Summary	Predadoor coil cord to wireless bottom bar retro				
Products Affected	Predadoor				
Key Word Tags	Wireless, Retro, Coil Cord,				
Tools/Equipment (If Required)					
Parts/Materials (If Required)	LH Wireless Bracket Assy R1060259-1, OR RH Wireless Bracket Assy R1060259-2 EPROM V02-05.38 R0111039 (If Required), Coupler Shaft, Feig RS703988, 3/8" Lock Washer R0554118, Flat Washer R5550015-0Z01, System 3 Control Board R00141006 (If Required), Bottom Bar Assy LH R1060057-1 OR Bottom Bar Assy RH R1060057-2, Encoder Cable R00141086				
Related Media					
Author	Mason Barnett, RevA M. Burzlaff	Issue Date	9/02/2011	Status	Active

PLEASE READ THE ENTIRE BULLETIN BEFORE PROCEEDING WITH RETRO

Figure 1

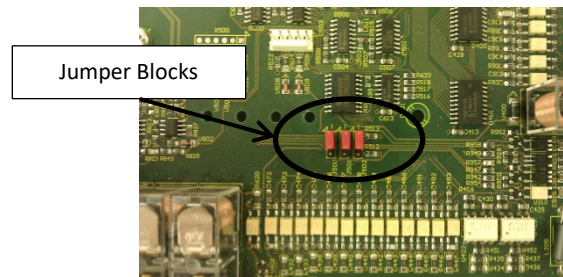
Customers requesting to convert from coil cord to wireless on their door will need to check the control board for encoder red block jumper availability. If the board has solder dots instead of jumpers, the board will need to be replaced. (See Figure 1).

Figure 2

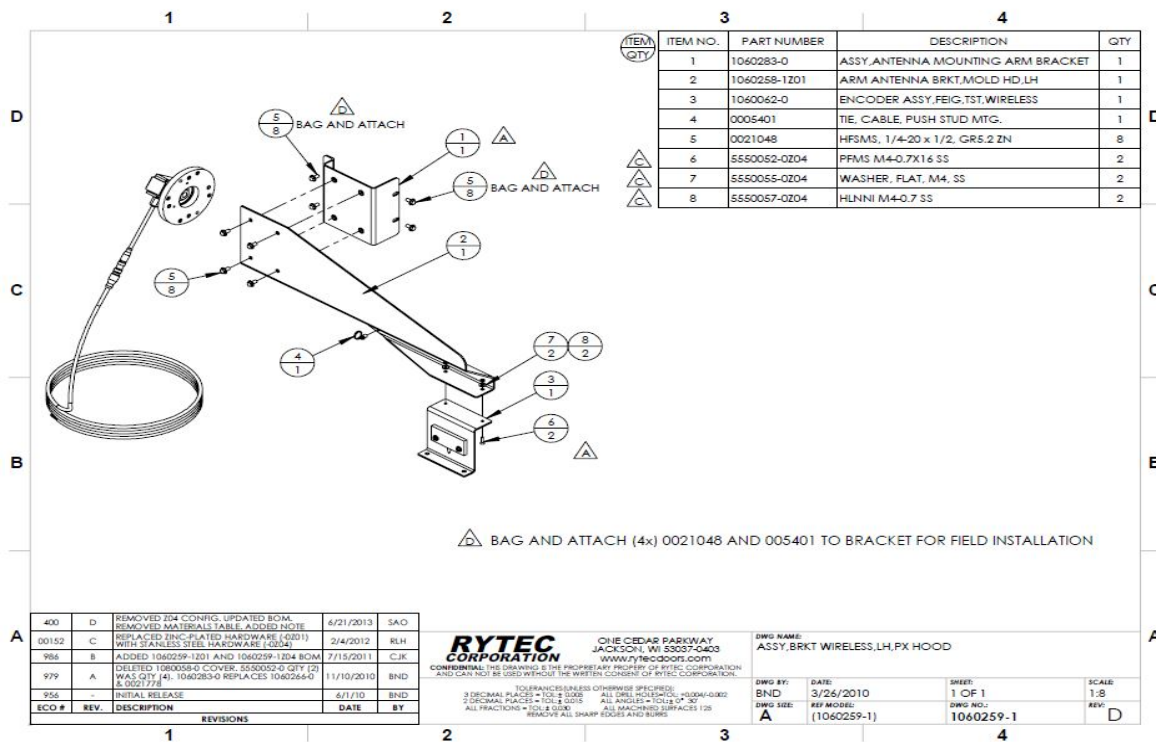
If the door was sent out prior to 11/1/03 and the board was never replaced and software was never upgraded, the customer will need get a new System 3 board. You will also need to check the drive side of the door to make the proper selection for the mobile unit antenna mounting bracket. (See Figure 2 for LH & Figure 3 RH Antenna Assemblies, Figure 4 Bottom Bar Assemblies).
